**APPLICATION OF AVANT OPERATING, LLC FOR
COMPULSORY POOLING AND APPROVAL OF
NON-STANDARD HORIZONTAL
SPACING UNIT, LEA COUNTY, NEW MEXICO**

CASE NO. 24544

**SECOND AMENDED HEARING PACKET IN SUPPORT
OF THE OBJECTION BY PRIMA EXPLORATION, INC.
TO THE APPLICATION OF AVANT OPERATING, LLC
FOR COMPULSORY POOLING AND APPROVAL OF
A NON-STANDARD HORIZONTAL SPACING UNIT,
LEA COUNTY, NEW MEXICO**

SECOND AMENDED HEARING EXHIBIT PACKET
TABLE OF CONTENTS

Prima Rebuttal Exhibit 6 Continued – Rebuttal to Avant Rebuttal Exhibit G-17

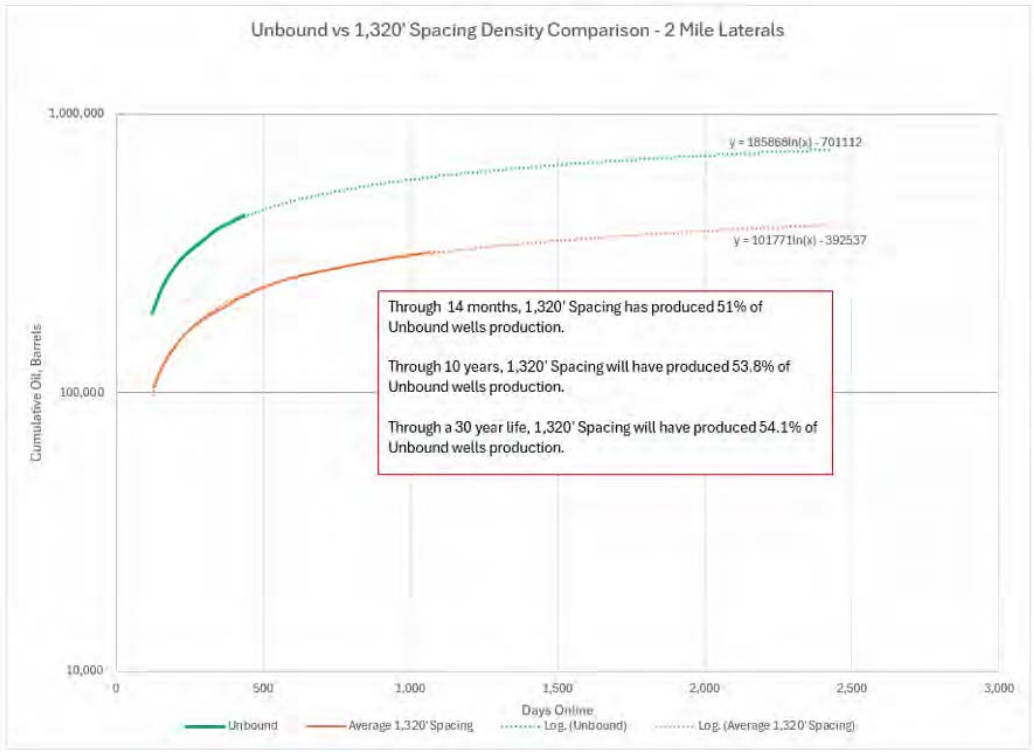
- The Buffalo 1H, when unbound, recovers nearly 2x the amount of oil as the infill wells offsetting it
 - This despite being 1,671' away from the nearest infill well
- Through the first year, it is 2x the amount of the infills
- Thus, the ROR approaches 2x that of drilling at a 4 WPS density
- Thus, drilling excess wells diminishes the returns of both the unbound and the infill wells
- Further, it destroys the ROI, as the capital expenditure is greatly increased
- Stacked wells interfering with each other between zones again brings up the concern that 4 wells per bench will lead to even greater interference within each zone, as the wine-racked wells in other benches will frac into each other and contribute to interference and economic waste

Prima Rebuttal Exhibit 7 – Rebuttal to Avant Rebuttal Exhibits G-18 and G-19

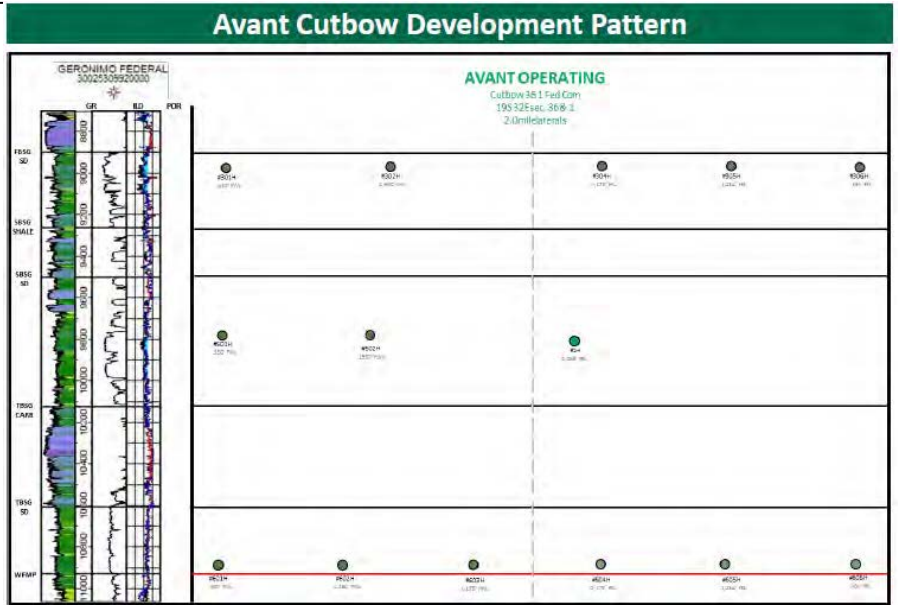
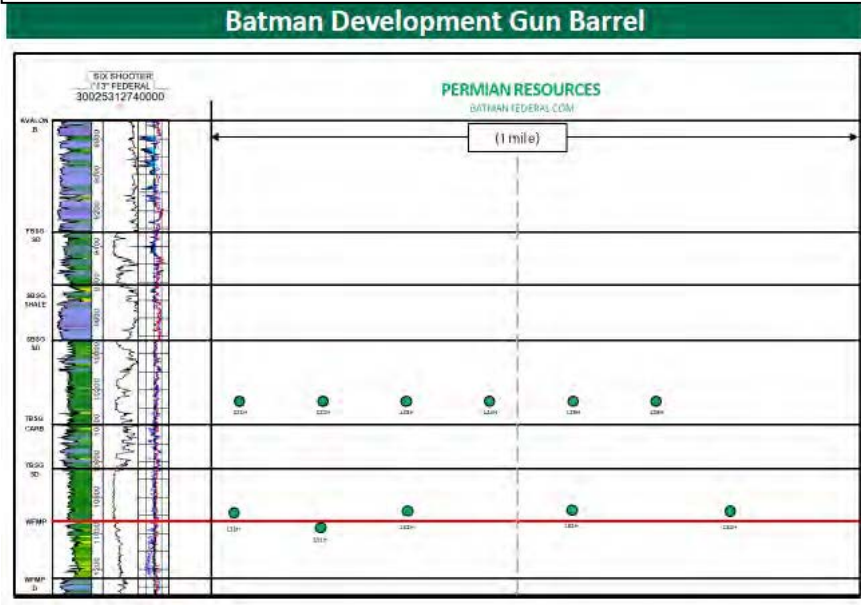
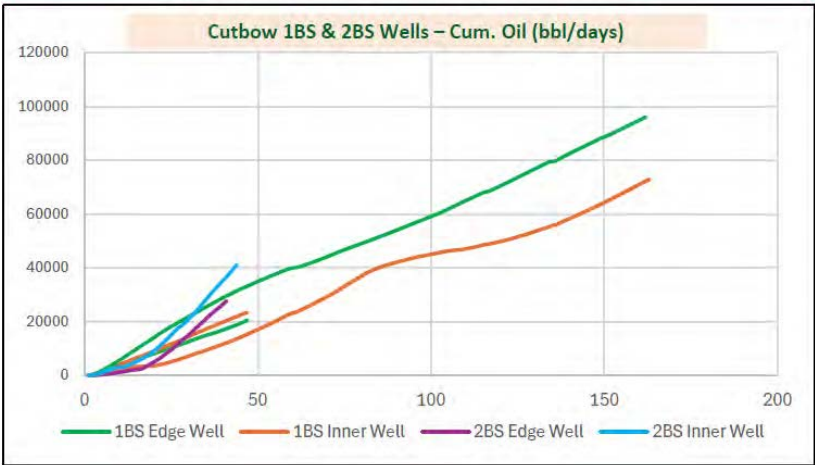
- Gone are the stacked bench impact arguments
- Discussion of inner vs outer wells is incomplete
 - Admit that longer timeframe indicates outer are better
 - Try to use less than 2 months of data to argue that inner wells are better
- With so many wells coming on at the same time, impact of density is muted in the short term that we have data
